Sub-Regional RTEP Committee – Mid-Atlantic FirstEnergy Supplemental Projects Cancellations

November 17, 2022

Penelec Transmission Zone M-3 Process Tiffany - Thompson 115 kV line: Pentagon 115 kV Tap - Cancellation

Penelec Transmission Zone M-3 Process Penn Mar – High Point – Rockwood 115 kV line - Cancellation

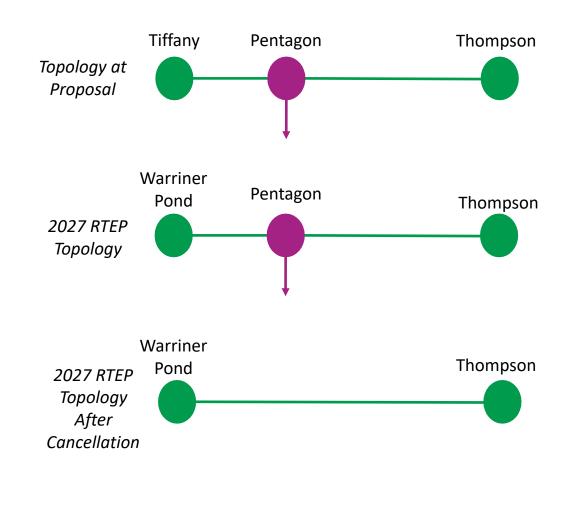
Cancellation Reason:

The customer is not progressing with the intended load addition.

No facilities have been constructed to date.

■ The creation of Warriner Pond substation (b3245, ISD: 6/1/2025) replaces the termination of the Thompson line at Tiffany.

After Cancellation

Warriner Pond – Thompson 115 kV

• 133 / 160 MVA (SN / SE)

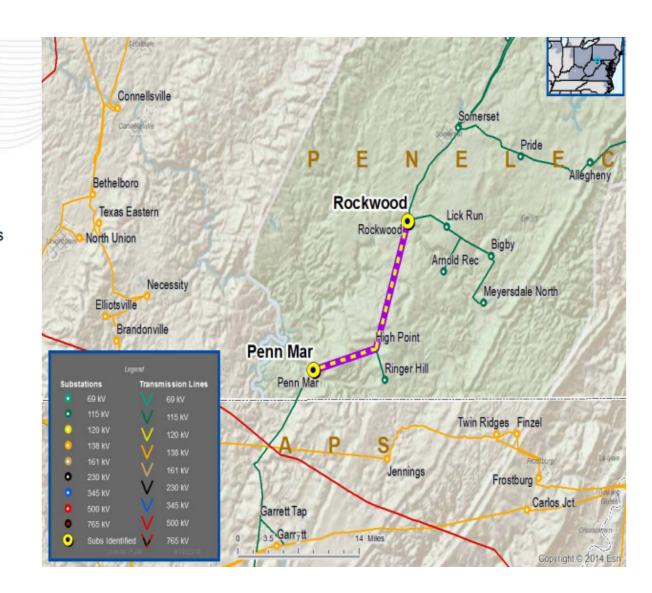
Cancellation Reason:

A subsequent inspection of the line yielded a lower priority in relation to other facilities that are now inspected.

No upgrades have been constructed to date.

After Cancellation (Existing)

Penn Mar - High Point 115 kV

• 148 / 179 MVA (SN / SE) - Line Limited

High Point - Rockwood 115 kV

• 148 / 179 MVA (SN / SE) – Line Limited
